OICA comments on GTR 21
EVE-IWG #61
25.-26.04.2023

■ Revision proposal summary

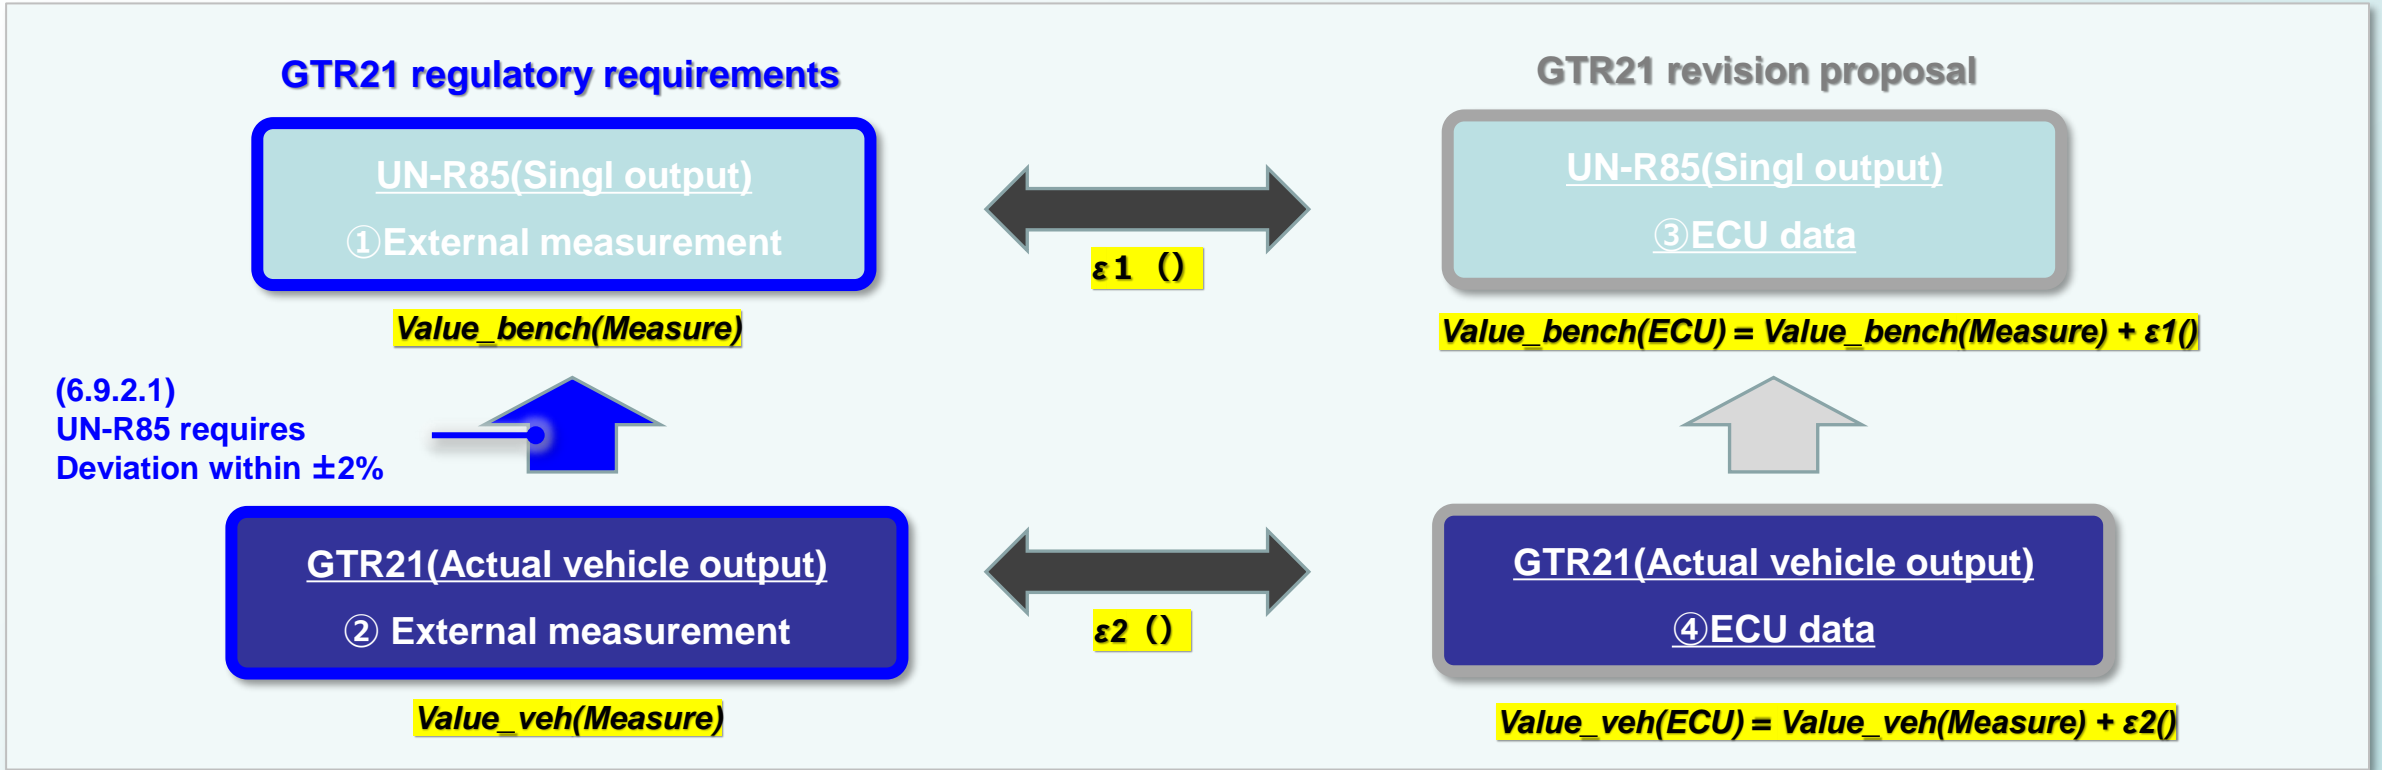
The difference between the controlled external sensor and the ECU signal greatly exceeds the sensor accuracy requirement of $\pm 50\text{Pa}$.

Pressure error between external measuring instrument and ECU signal value

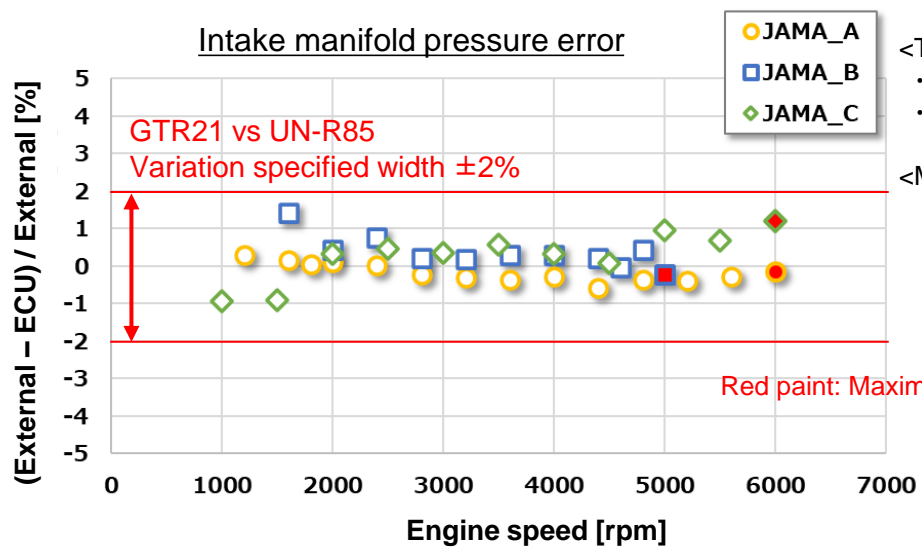
Variation is defined by defining the difference between external measurement and ECU as ϵ

If $(\epsilon_1 - \epsilon_2) \approx 0$ then external measurements can be replaced with ECU signal values

Investigate the variation ϵ between the external measurement value and the ECU value

■ UN-R85 variation result JAMA 3 company results

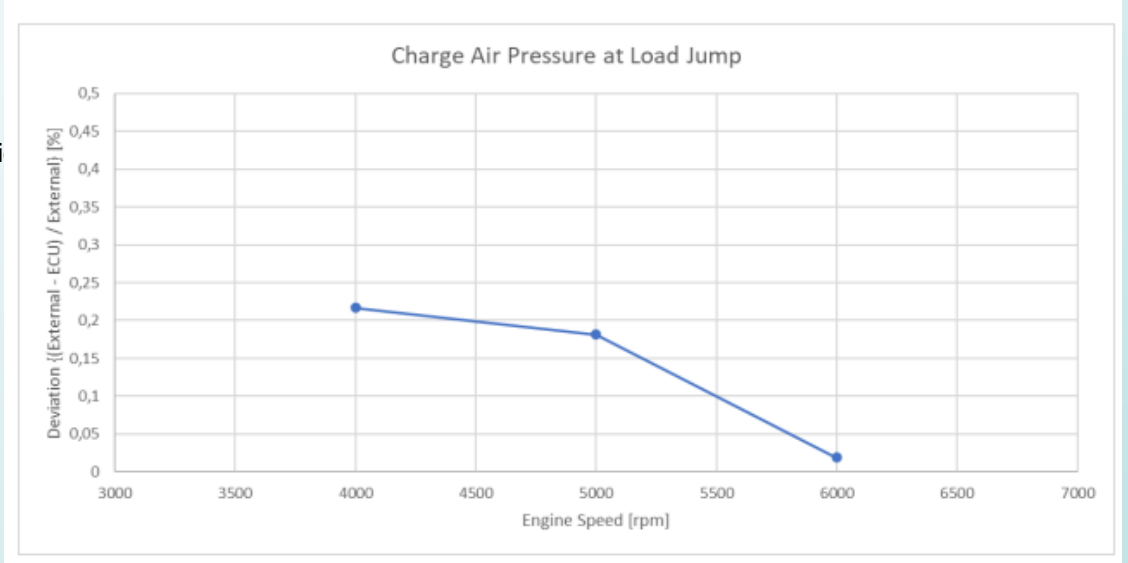
Both UN-R85 and GTR21 results are within $\pm 2\%$ of variation between external measuring instrument and ECU value

- The required accuracy of ± 50 Pa for intake manifold pressure does not need to be met if the variation is within $\pm 2\%$ by comparing the external sensor and ECU values, and the results can be used for those with the same on-board sensor system.
- The same on-board sensor system can be used for the comparison of variation between GTR21 and UN-R85 using ECU values that meet the above requirements.
